## DEVELOPMENT DETERMINATION PANEL MEETING

**WEDNESDAY 20 DECEMBER 2017**

**ITEM 3.1**                      **N0021/17/S96/1 - 41 WALWORTH AVENUE, NEWPORT - SECTION 96(1A) MODIFICATION TO CONSENT N0021/17 RELATING TO 41 WALWORTH AVENUE, NEWPORT (LOT 31, DP 9877) WHICH APPROVED THE DEMOLITION OF AN EXISTING DWELLING AND THE CONSTRUCTION OF A NEW DWELLING**

**SUBJECT: N0021/17/S96/1 – Section 96(1A) Modification to Consent N0021/17 relating to 41 Walworth Avenue, Newport (Lot 31, DP 9877) which approved the demolition of an existing dwelling and the construction of a new dwelling**

**Figure 4:** The approximate location of where the height standard would be breached (indicated by the red box). For reference, the maximum ridge height of the roof is indicated by the green lines.

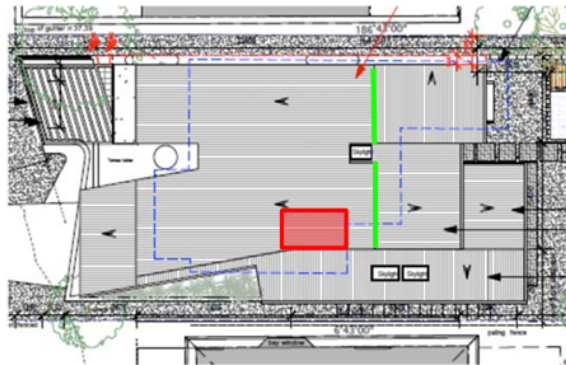
Information submitted with the subject modification application indicates that the proposed dwelling (as modified) would comply with the height standard, though the maximum “reduced” height of the dwelling is not specified.

A review of the original application suggests that the proposed building height was incorrectly calculated, as it measured the height of the dwelling from natural ground level, instead of the “existing” ground level of the former dwelling’s lower-ground level in accordance with the “building height” definition within the LEP. While the breach of the standard was not addressed within the planning report for the original approval, the recommended changes to the proposed building height as part of consent condition B1 would have reduced the height of the dwelling so that it complied with the height standard.

Despite a proposed 200mm reduction in the height of the light wells, the restoration of the original building height through the proposed modifications to condition B1 would result in a maximum building height of 8.78m (i.e. a 280mm, or a 3.3% variation to the standard); due to the proposed slope of the roof the size of the noncompliance would progressively decline to a point where the building height would otherwise comply with the 8.5m height standard. The breach occurs within a small (i.e. approximately 6m<sup>2</sup>) section of the western light well, and would be situated below the maximum proposed ridge height of the wells (refer to figure 4 above). With regard to the assessment of Clause 4.6 of PLEP 2014 (below) and the likely design impacts of modifying only the noncomplying part of the roof, it is recommended that the pitch of the roof be changed so that the height of the light wells is reduced by a further 280mm (i.e. to a maximum RL of 40.07) so that the height of the dwelling complies with the height standard.

Due to the proposed design of the roof, any requirement to reduce the noncomplying part of the light wells so that it complied with the light well would likely have an adverse impact on the design of the roof and the function of the light wells. Further, if only the western (i.e. the noncomplying) light well were modified, then the roof would not be of a single plane as proposed by the applicant. It is therefore recommended that a condition seek a reduction in the pitch of the light well roof so that the ridge height of the light wells is reduced by 280mm (i.e. to a height of RL 40.07).

**Figure 13:** Extracts from the approved Site Plan (top) and Ground Floor Plan (bottom); note the references to "established screen planting" and "established continuous screen planting" on the respective plans.

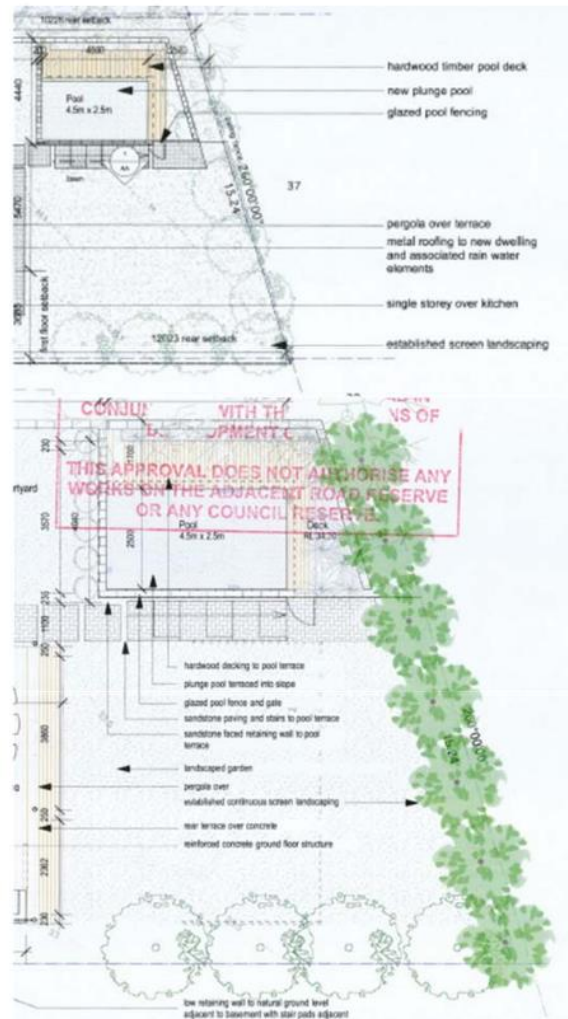
Despite the above, inspections of the site and discussions with the objectors noted that the applicant has removed landscape screening along the side and rear boundaries of the subject site. While there were no conditions explicitly referring to such treatments, the approved plans repeatedly indicated that "established screen planting" was to be situated along these boundaries.

The originally approved plans related to established landscape screening, however it is unclear whether such landscaping is to be reinstated; a new condition is therefore recommended that would require dense screening vegetation to be planted along the rear and western side boundary of the subject site. Such a condition would require such vegetation to consist of locally native species (thereby satisfying natural environment development controls). Further, the condition would require that the mature heights of such vegetation be maintained at:

4. Consent condition B22 is to be added as follows:  
"Landscape screening is to be implemented along the entire rear boundary and western boundary of the rear setback area (i.e. the area between the rear building line and the rear property boundary). Such landscape screening shall:

- Contain selected species that are capable of growing to a mature height of at least:
    - Four (4) metres for plants along the rear boundary; and
    - Four (4) metres for plants along the west side boundary.

JOB NO 1604  
DWG NO A-201  
AMENDMENT H  
TITLE ELEVATIONS 2  
SCALE 1:200 AT A3  
DATE PRINTED 29.11.17  
SIMON ROSEWELL PTY LTD  
architecture • design • project management

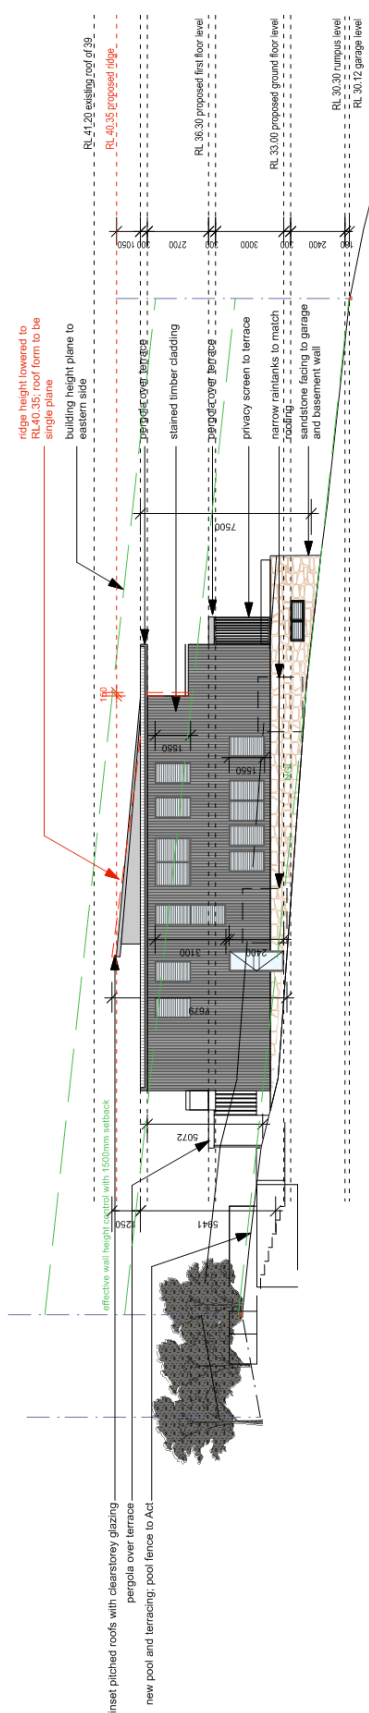
In addition to the above, the subject modification application proposes changes to the rooftop light wells. The proposed changes are as follows:

- Reduction of height of the light well by 200mm (i.e. the maximum ridge height of the wells would be RL40.3); and
- Modifications to the design of roof to close the centre gap between the light wells, effectively "connecting" them in the middle to form a single roof plane.

5. Consent condition B23 is to be added as follows:  
"The pitch of the roof above the light wells is to be modified to reduce the height of the ridge RL of the light well roof by 280mm to RL 40.07."
